CITY OF ORLANDO

RE: Letter of Determination for Administrative Specific Parcel Master Plan for ±352,000
sq. ft. Warehouse/Distribution Center, south of 3650 8th St./Express Ln., Orlando, FL
(Tract C of Air Commerce Park PD, part of Parcel ID #05-24-30-0000-00-003)
LDC2016-00299

Elevations

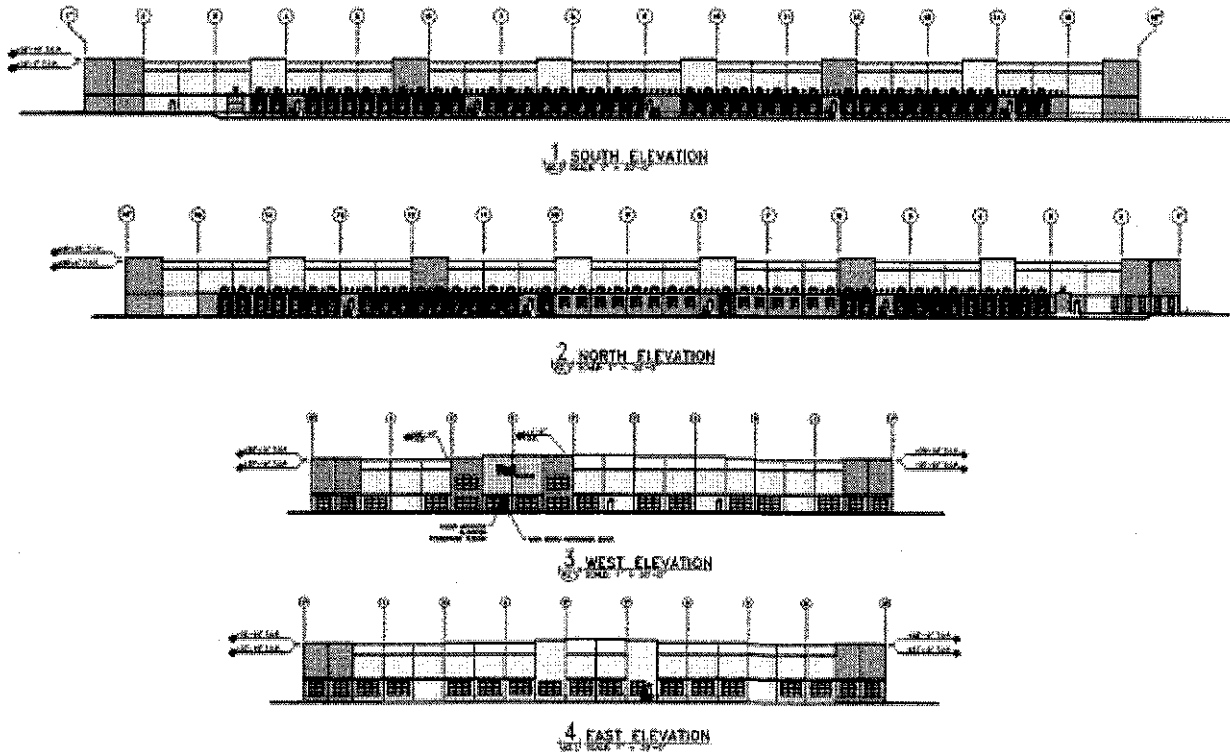
The pedestrian entrance must be architecturally highlighted more than shown in the proposed west elevation (see condition (a) above). Canopies, awnings, recesses, projections, parapet height, etc. may be required to meet this.

2. The parapet height in general must have greater changes across the building facades.
3. Rooftop HVAC equipment must be fully screened, per City Code. The preference is for parapets to exceed HVAC equipment height, but architecturally compatible enclosures will be also acceptable for HVAC screening.

4. Materials at the base of the building must be durable. Stucco or foam insulation will not be considered durable materials. A building base, that includes material changes, at least 3 feet in height will be required in the west elevation and in the front 80 feet of each of the north and south elevations.
